Model: LCIT RT5070		Date: 25-Jun-15	No.: RD733001
Subject: New LCT side fence for higher safety		Prepared by: J. Ohno	
From: 1st Tech Service Sect., PP Tech Service Dept.			
Classification:	<input type="checkbox"/> Troubleshooting <input type="checkbox"/> Mechanical <input type="checkbox"/> Paper path <input type="checkbox"/> Product Safety	<input checked="" type="checkbox"/> Part information <input type="checkbox"/> Electrical <input type="checkbox"/> Transmit/receive <input type="checkbox"/> Other ()	<input type="checkbox"/> Action required <input type="checkbox"/> Service manual revision <input type="checkbox"/> Retrofit information <input type="checkbox"/> Tier2

Old side fence (p/n: D7332573)

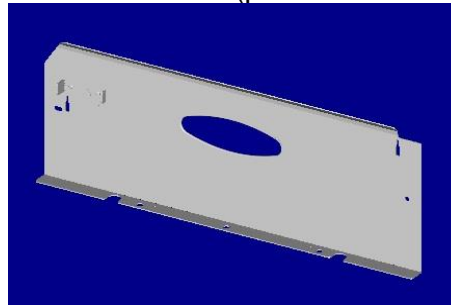
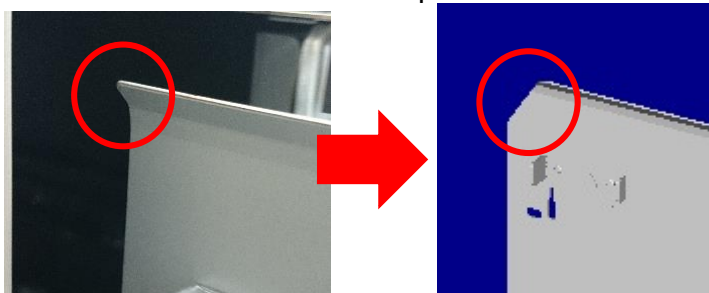
The sharp top rear corner of the side fence of the LCT was rounded off for higher safety.

To prevent injuries in case operators forcefully stick in their hands to remove jams

Modification point

New side fence (p/n: D7332833)

Old side fence (p/n: D7332575)

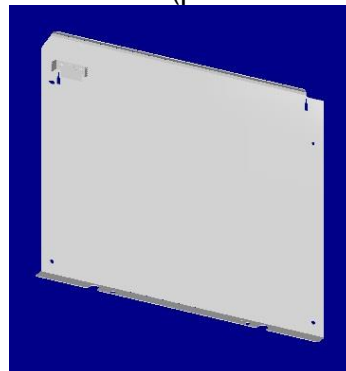
Modification point

New side fence (p/n: D7332852)
